COMPARISON OF NRC PROTOTYPE AND CAL MODEL  
OF AFC CHASSIS FOR AN/MPS-501B

A. C. HUDSON AND R. L. WESTBY

AUGUST 1957 NRC # 35572

Some difficulties have arisen with the AFC chassis for the AN/MPS-501B radar, and the present report compares in detail the chassis as manufactured by Canadian Arsenals Limited, and the prototype designed by the Radio and Electrical Engineering Division of the National Research Council in 1954. The prototype design is described in Report ERA - 264.

FIG. 1 TORQUE REQUIRED TO MOVE SERVOMECHANISM

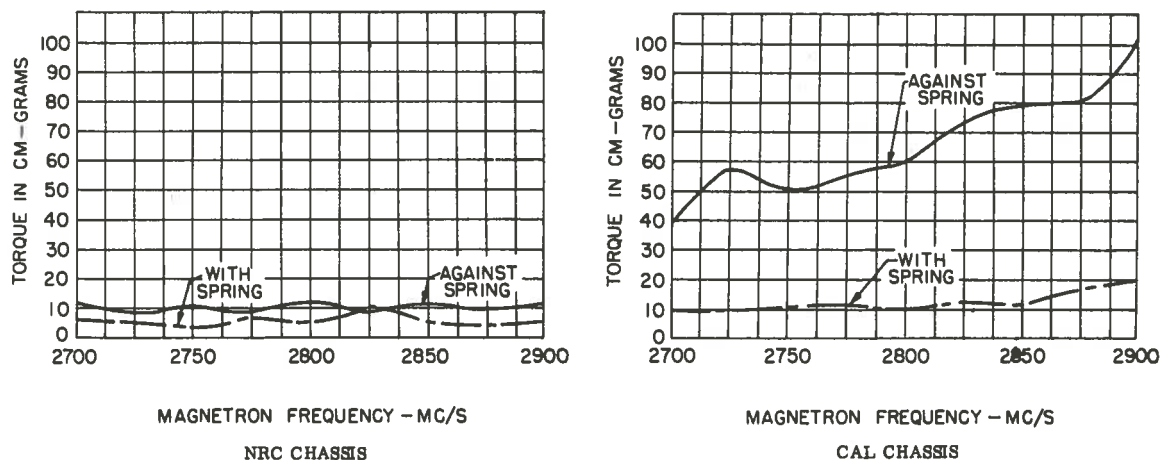
Fig. 1 compares the NRC and CAL chassis from the point of view of torque required to start the mechanical servomechanism, as a function of local oscillator setting. The CAL gearbox has been redesigned in such a way as to increase the number of moving parts. The spring has also been altered.

The factor which seems to have had the greatest effect in degrading the performance is the design change which has resulted in the increased torque required by the local oscillator gearbox (see Fig. 1).

FIG. 3 LIMITER CHARACTERISTIC

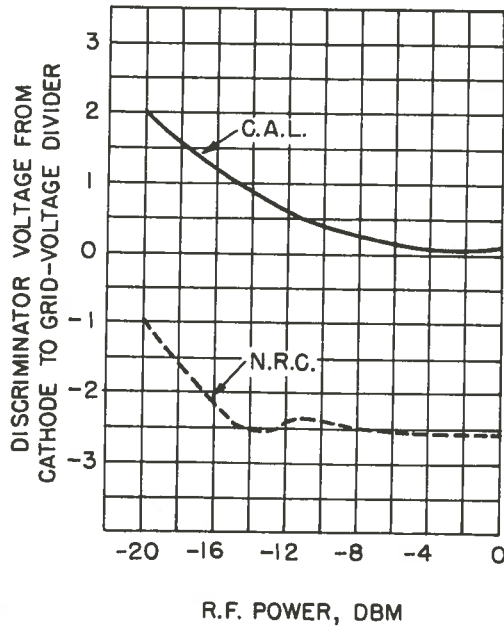
The limiter characteristic (measured from the cold end of the 180 K resistor in Fig.27 of ERA-264 to the discriminator cathode) is shown in Fig. 3, for the NRC and CAL chassis. It can be seen that considerable difference in d-c level exists, and also that there would seem to be very little limiting in the CAL chassis.

FIG. 4 DISCRIMINATOR CHARACTERISTIC

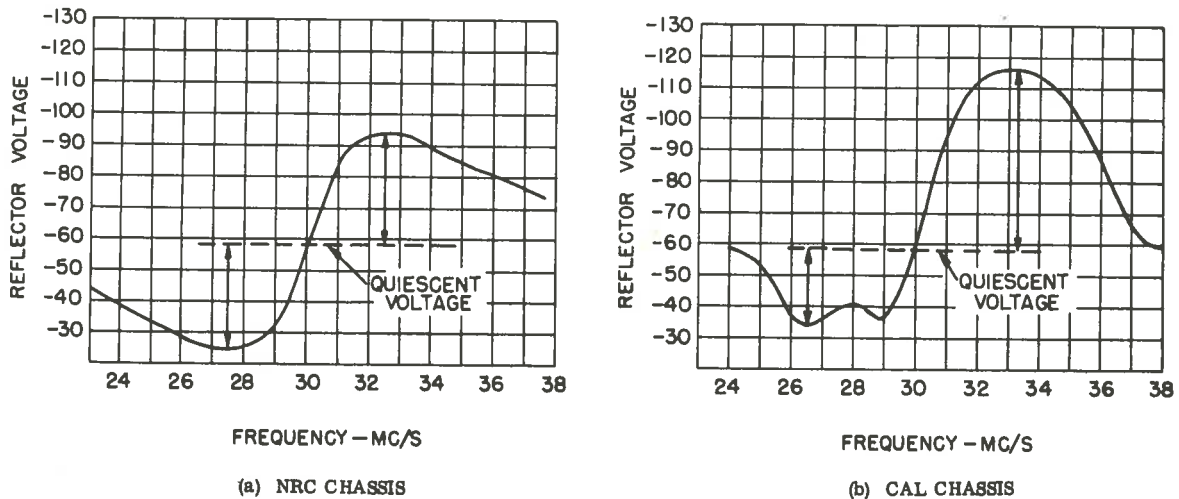
Fig. 4 (b) represents the best characteristics which could be obtained in the CAL model. The primary trimmer (see Fig. 27 of ERA-264), the function of which is to equalize the peaks, failed to do so in the CAL chassis.

FIG. 5 SCHMITT TRIGGER OPERATION

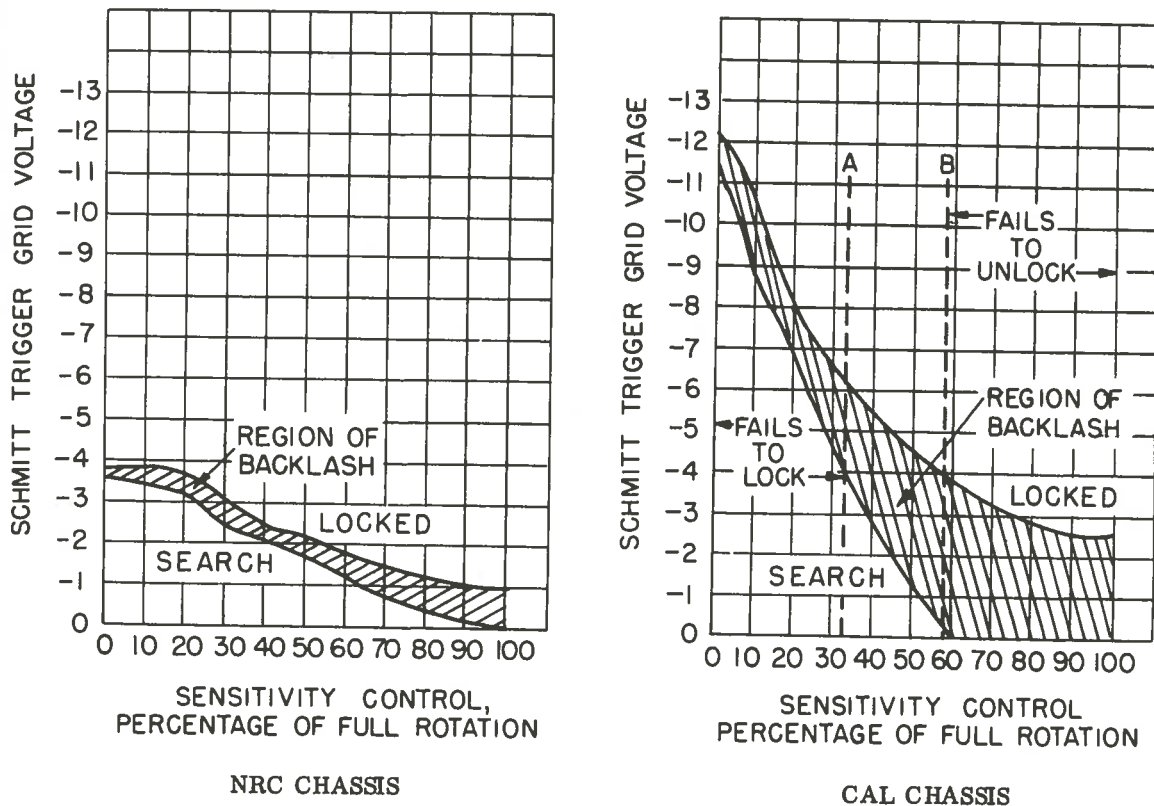
On the CAL model, operation is possible only in the region A to B of Fig. 5.
